Agenda Item: 620-2082

Title: API 620 Low Temperature Low Stress – Update to ASME 2025

Purpose: To provide updated rules to using ASME VIII-Div2-2025 Ed for low temperature/low stress provisions.

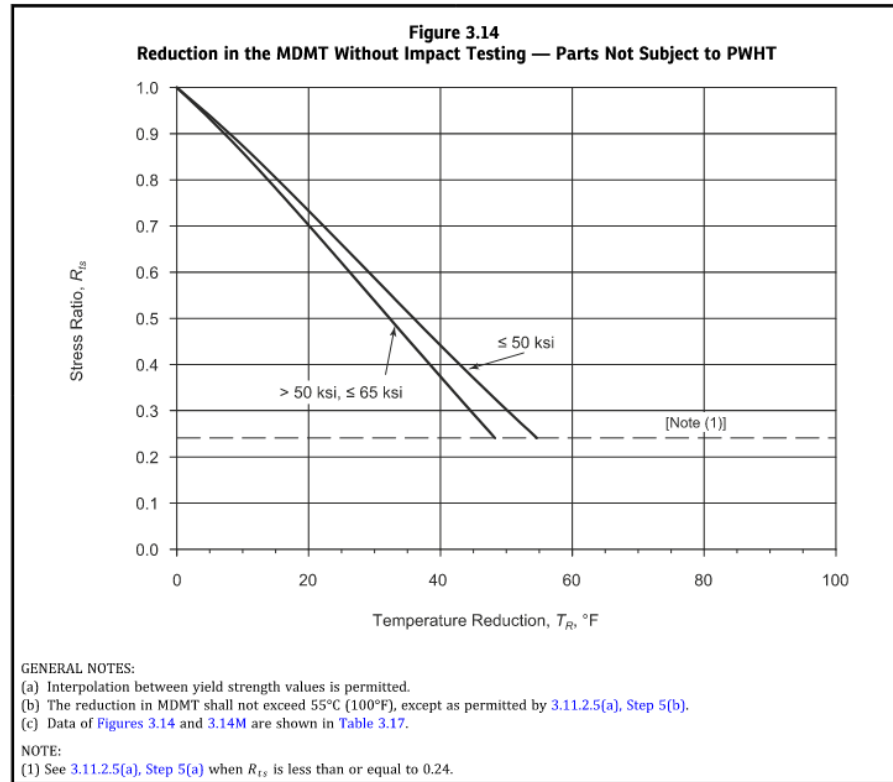
The proposal proposes using API 620 allowable stresses in lieu of ASME Class 1 allowable stresses. This approach is conservative. To support this, examples of stress ratios and corresponding temperature reductions are shown in the following tables.

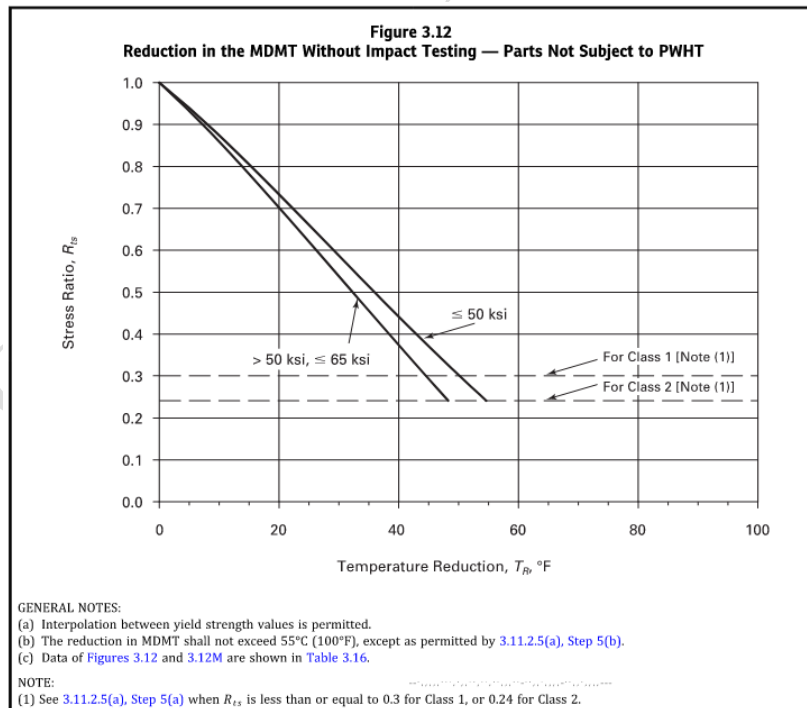
The below shows examples of the lowest R_{ts} .

In ASME VIII Div 2 (2023), Figure 3.12 required the minimum R_{ts} to be 0.3 for Class 1 and 0.24 for Class 2. In comparison to the stress ratios with API 620 allowable stresses, the minimum R_{ts} is approximately 0.33 on average.

Though Class 1 stress values are still accessible in ASME Section II Part D, it is proposed not to use either Class 1 or Class 2 allowable stresses for stress ratios but use only API 620 allowable stresses and limit the actual 620 stress ratio to be not lower than 0.33.
